# LiDAR Quality Assessment Report

SC\_LexingtonCo\_2010

Lexington County, South Carolina,  
Collection Dates: 03/14/2010 -  
03/27/2010

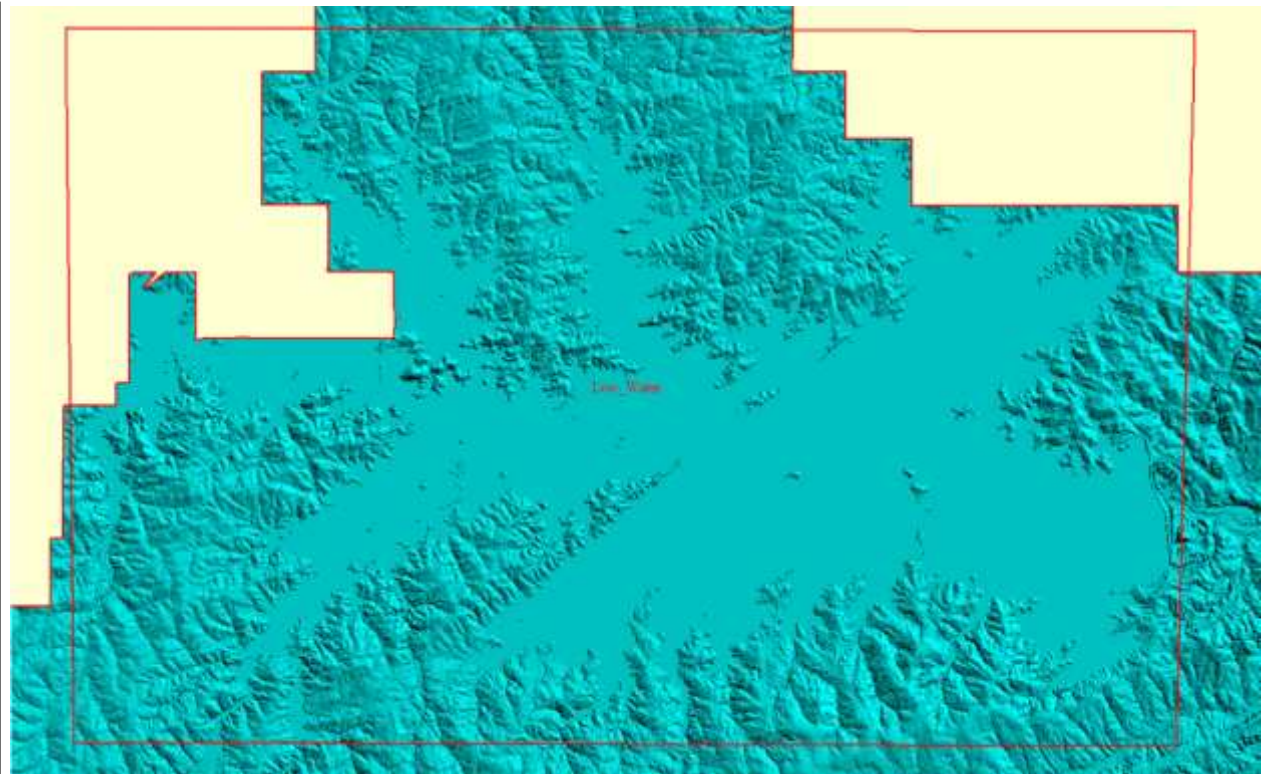
low water at location  $34^{\circ} 04' 35.1474''$  N,  $81^{\circ} 21' 8.9059''$  W

The corrections were received in August 2013. The water level was raised, however there was an error which was corrected with a triangulated patch in the DEM only.
